TPM CIRCLE NO :-		ACTIVITY	KK	QM	PM	JH	SHE	OT	DM	E&T	KAIZEN IDEA SHEET
			TPM CIRCLE NAME:		LOSS NO. / STEP									KAIZEN NO:-07
	DEPT :- IQA			RESULT AREA	Р	Q	DEF :- /	4	С	D	S	М	RAIZEN NO07	
CELL :-A312 CELL NAME:			MACHINE	CHINE / STAGE :- Supplier End Matrix						OPERATION :- PDC

KAIZEN THEME To prevent A312 body flash on profile

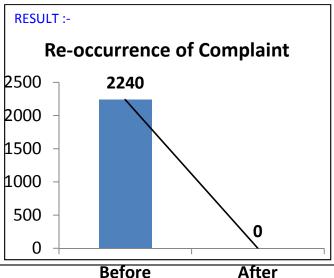
BEFOR
WHY ANALYSIS :-	
−A312 mounting hole Ø 6.2+0).3 undersi
not enter in mounting hole

Why 1 size ,6.5 pin

Why 2 – Flash in mounting hole.

Why 3 –Gap in fix up side & moving side pin

Why 4 –operator removing flash manually

Why 5 -Single hole fettling by operator & skip it.

ROOT CAUSE: - 1)Single hole fettling by operator & skip it

COUNTERMEASURE:-1) Added both side pin in die to avoid flash defect in mounting hole.

IDEA: - Added both side pin in die to avoid flash defect in mounting hole.
